# SECOND & WALL

210 WALL STREET

EARLY DESIGN GUIDANCE MEETING 2  
DOWNTOWN DESIGN REVIEW BOARD  
FEBRUARY 16, 2016  
DPD #3020932

# TOWER LOCATION ANALYSIS

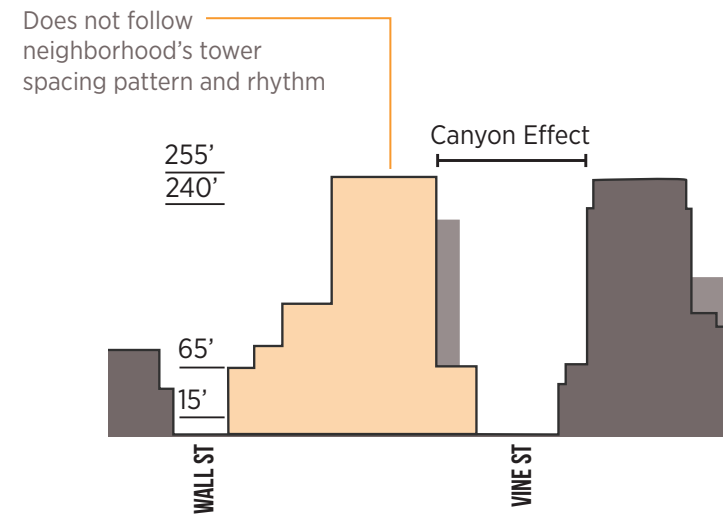
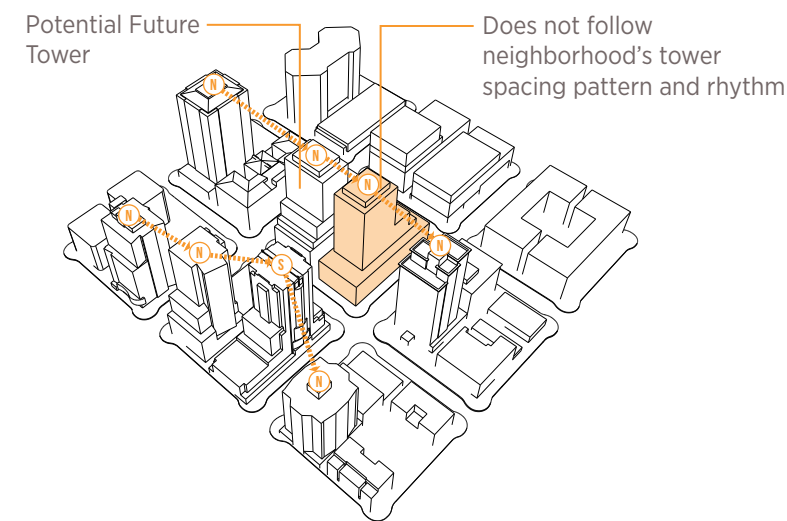
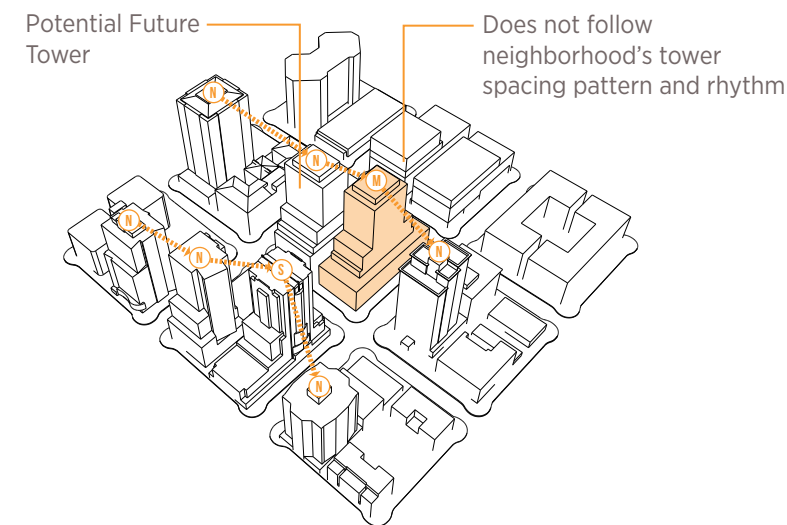
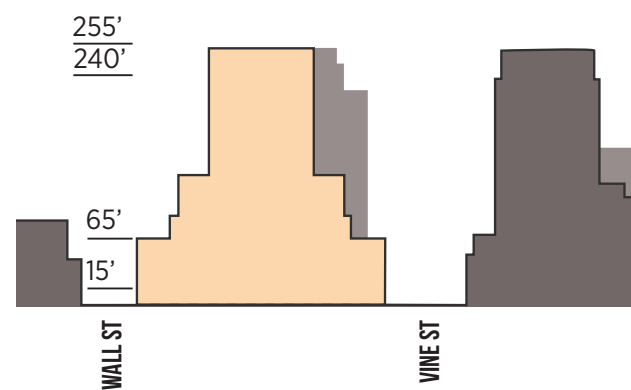
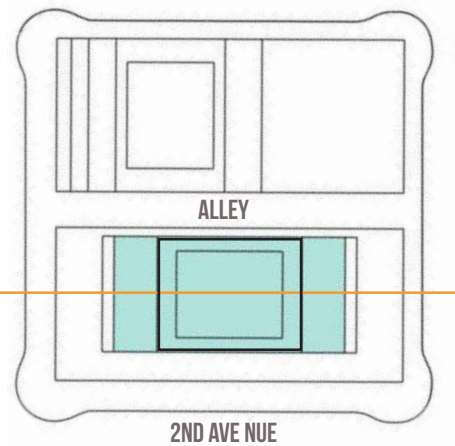
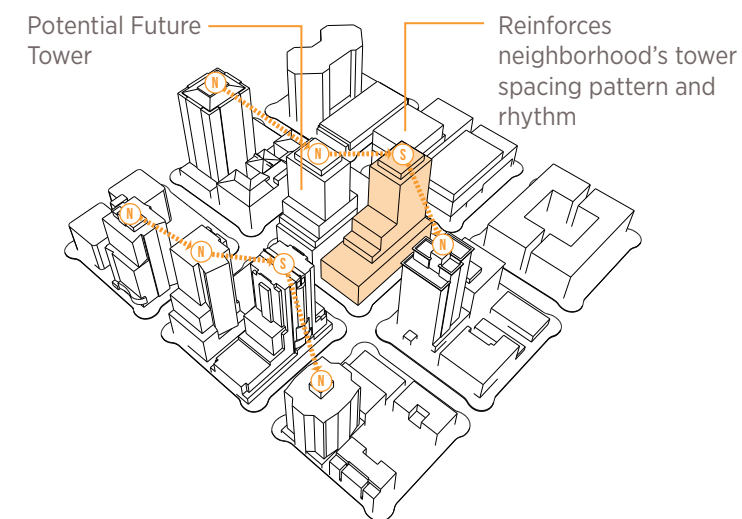
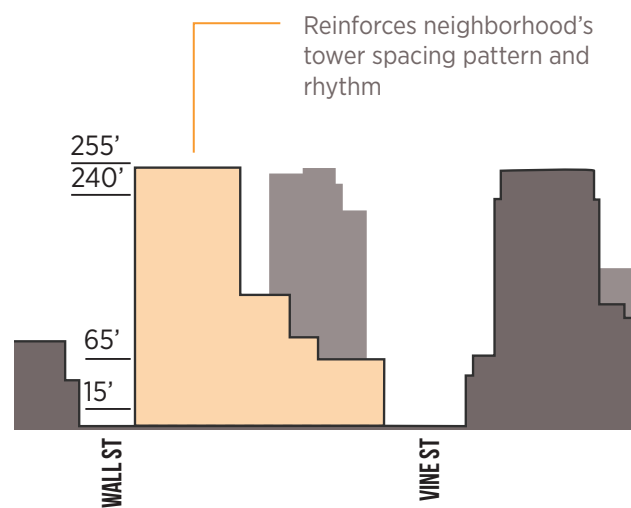
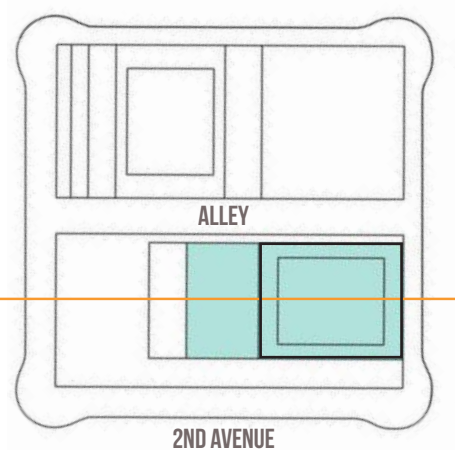
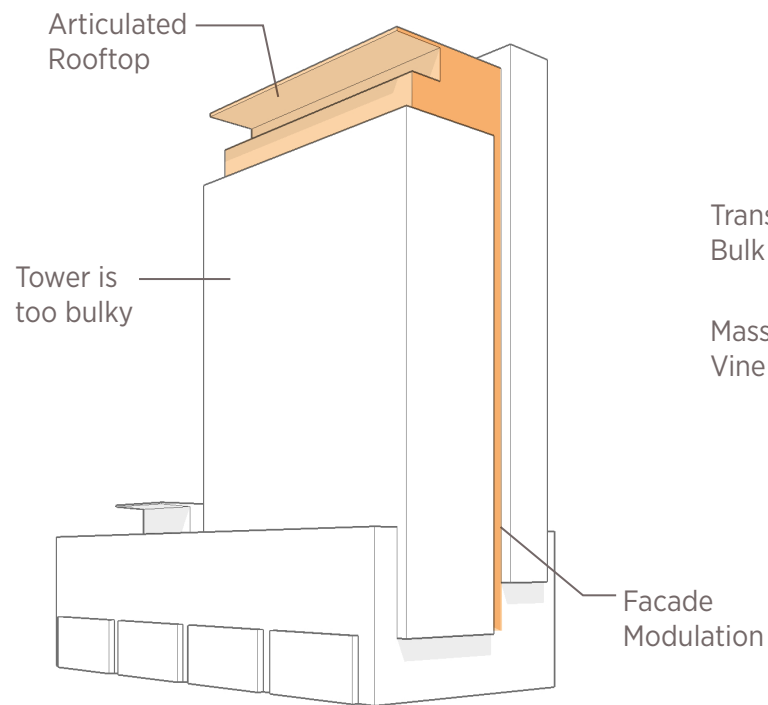
- All three massing options shown in EDG Meeting 1 located the tower on the south end of the site.
- The Board wanted to see more exploration of tower placement.

Tower to north:

- Very close to Seattle Heights, lessening privacy
- Creates canyon effect on Vine Street green street
- Blocks views from neighboring towers
- Is contrary to established tower spacing pattern in neighborhood

Tower in center:

- Blocks views from neighboring towers
- Is contrary to established tower spacing pattern in neighborhood

**PREFERRED TOWER POSITION: SOUTH**

- Allows the most air and light to Vine Street green street
- Least impact to neighboring towers' views
- Neighborhood Support expressed at community meetings and EDG Meeting 1 public comment period
- Continues the existing neighborhood tower spacing rhythm

# MASSING DEVELOPMENT

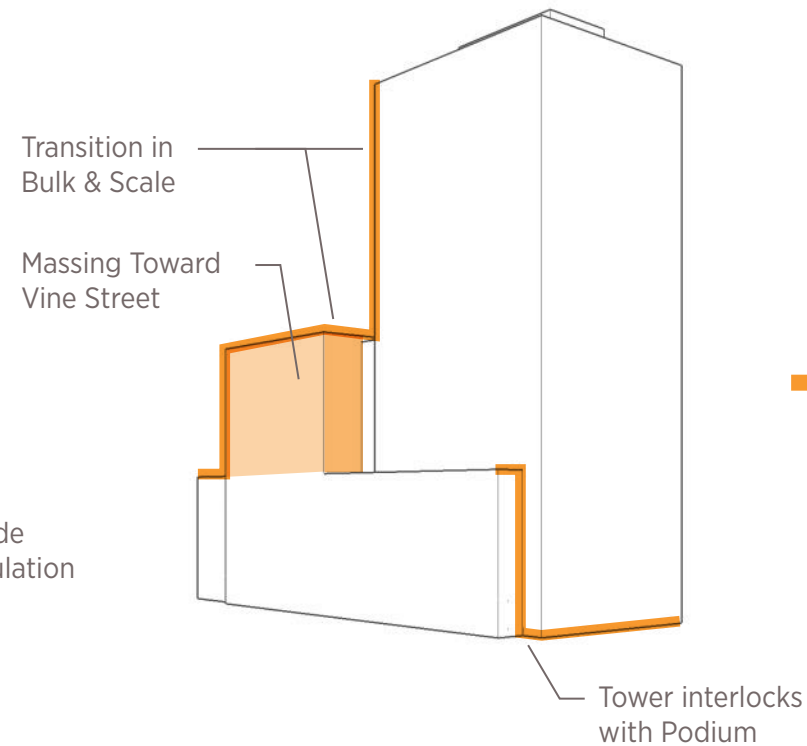
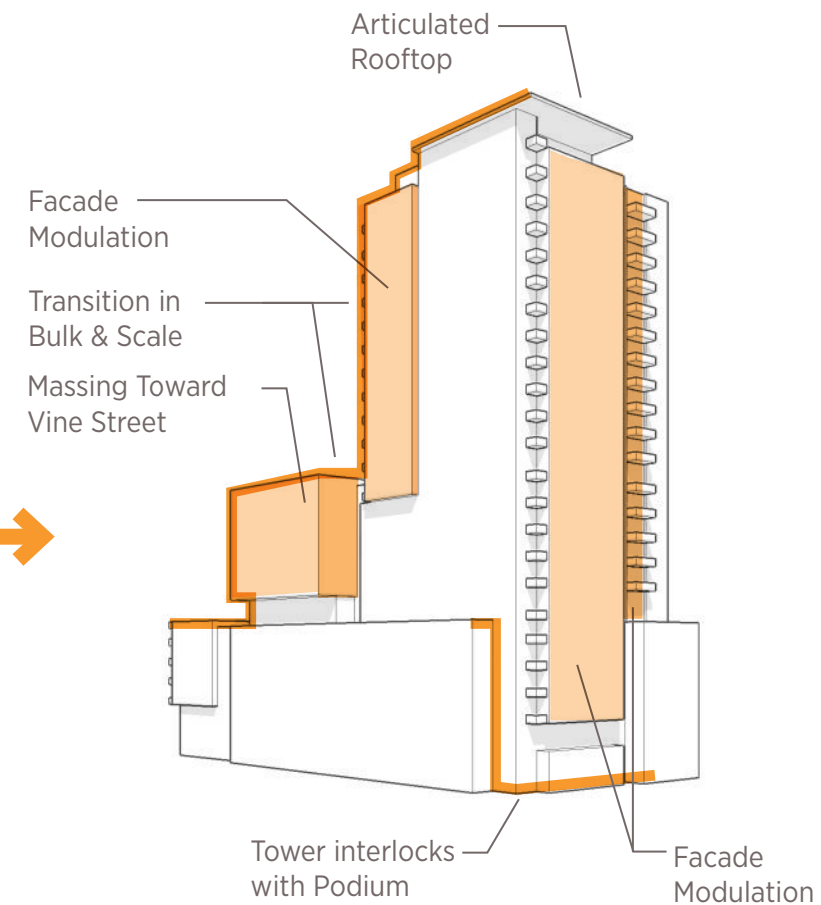
- The Board wanted to see options with various tower locations compared to the presented south tower location.
- The ‘mid-level’ concept #2 should be explored more fully as it has valid merits.
- The Board supported the tower-podium interlock of the preferred scheme.

Based on guidance given at the first EDG Meeting, the design team studied additional massing concepts while maintaining the south tower placement.

The preferred massing concept:

- Reduces impact to neighboring buildings by providing adequate separation between residential towers, maintaining privacy
- Provides opportunity for outdoor space on several levels at different heights
- Reduces perceived bulk on Vine Street (a designated Green Street), allowing pedestrian access to light and the sky
- Responds to intent of the zoning code by providing transitions in bulk and scale at various building heights
- Tower has been revised from 120'x85' (9,827 SF) presented at EDG #1 to 91'x87' (8,000 SF) as shown in the new preferred massing concept

DESIGN A WELL-PROPORTIONED BUILDING

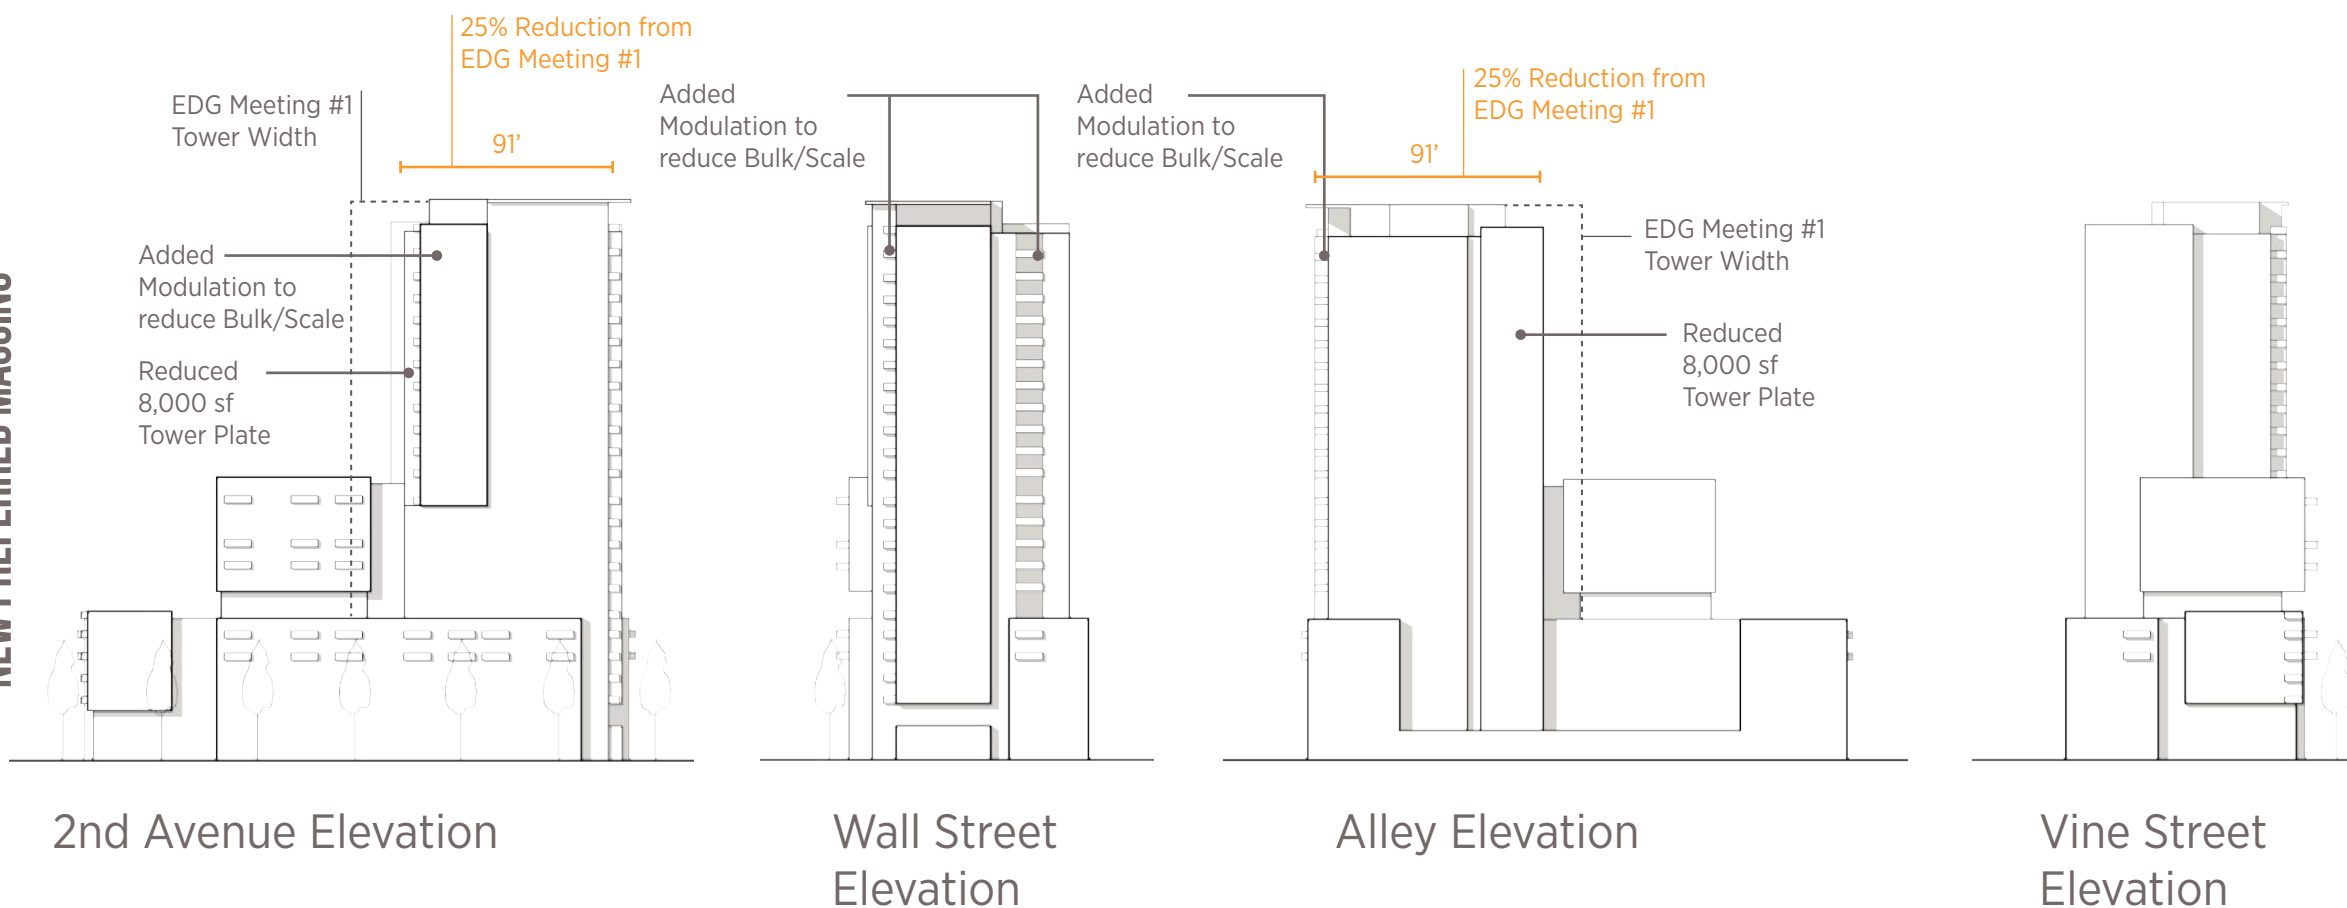
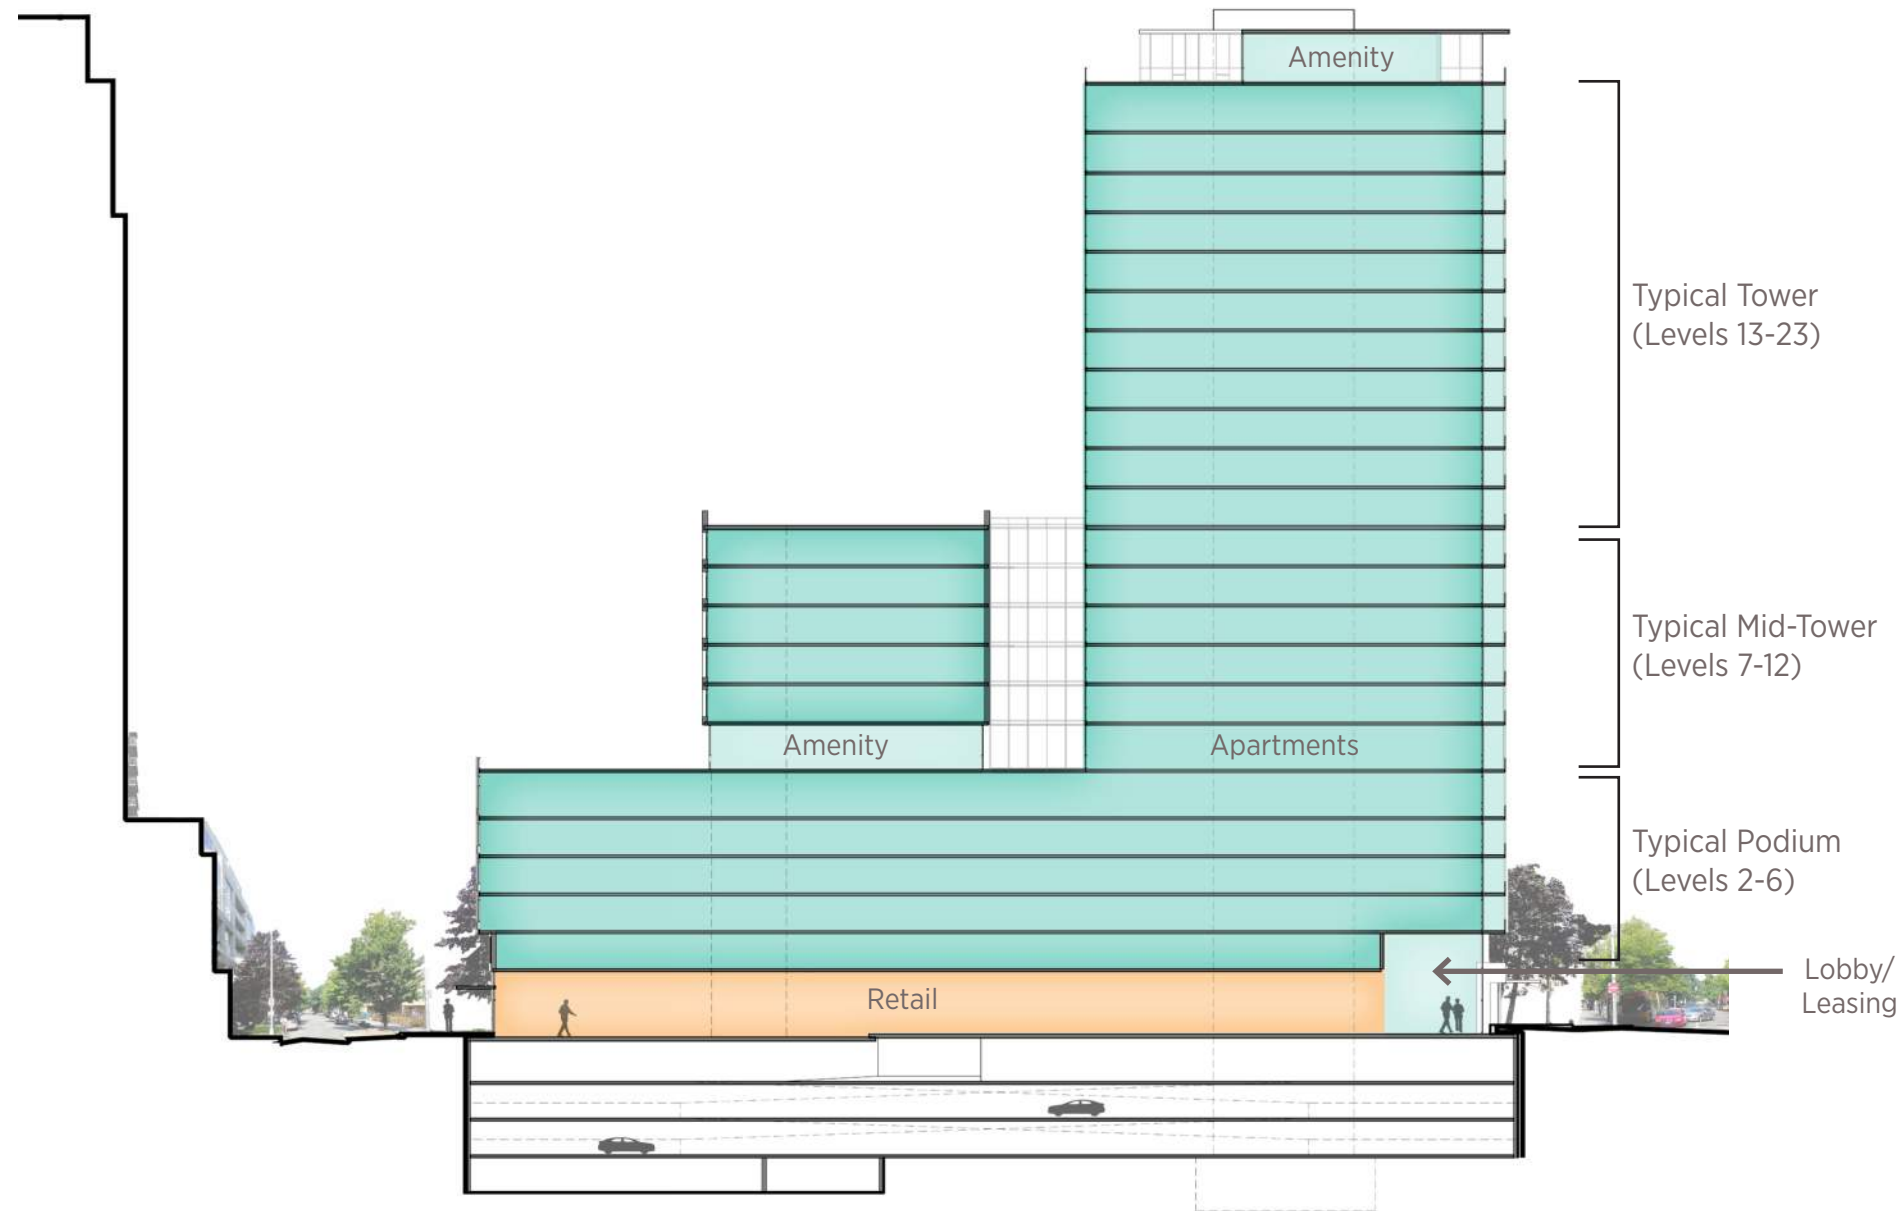
The Board supported the tower-podium interlock of the preferred scheme.

The preferred tower massing is too bulky and squat, and should be shaped to emphasize vertical proportions.

Present a less wide and flat tower wall to the south.

Break up the long tower elevation along 2nd Avenue.

The design team reduced the bulk and scale of the proposed massing by providing additional modulation through setbacks, revised tower proportions and reduced tower floor area.

The tower floor plate area was reduced from 9,827 SF as shown in EDG Meeting #1 to 8,000 SF per the Board's guidance.

# ENHANCE THE SKYLINE

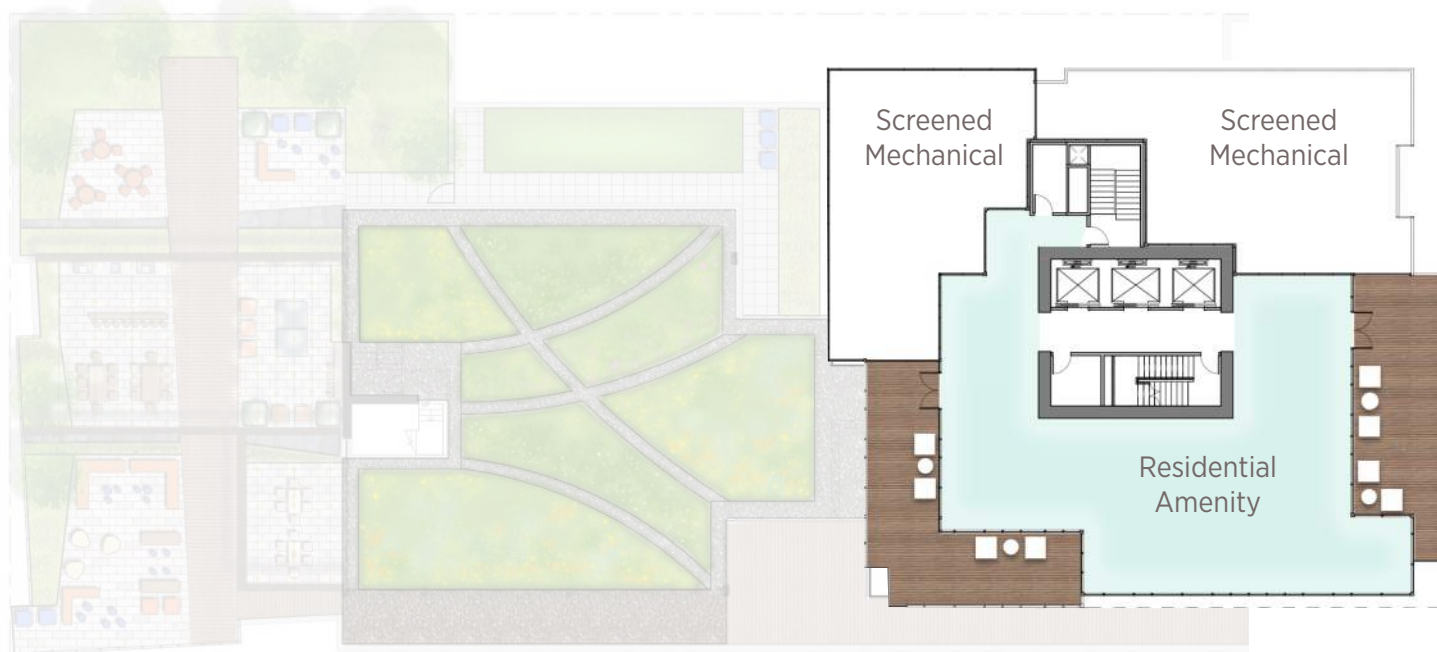
- The Board supported a rooftop that breaks down in scale and “enhances the skyline”.
- The Board supported a rooftop that integrates with the tower form rather than a “pillbox” atop the tower.
- Explore breaking down bulk of rooftop form. Potentially with perforated and/or transparent materials.

The step backs provide two distinct outdoor spaces. There are several opportunities for different types of gathering spaces to enjoy light and air, and views: indoor, covered outdoor, and non-covered outdoor.

The integrated roof extends over an outdoor area to the south, allowing for active uses year round. This roof expression, integrates with the overall tower form, not a “cap” on top.

- A** Residential amenity space integrated into tower form
- B** Tower mass forms outdoor amenity deck
- C** Soffit material creates an identifiable feature visible from the ground level
- D** Tower envelope material continue vertically to screen rooftop mechanical equipment
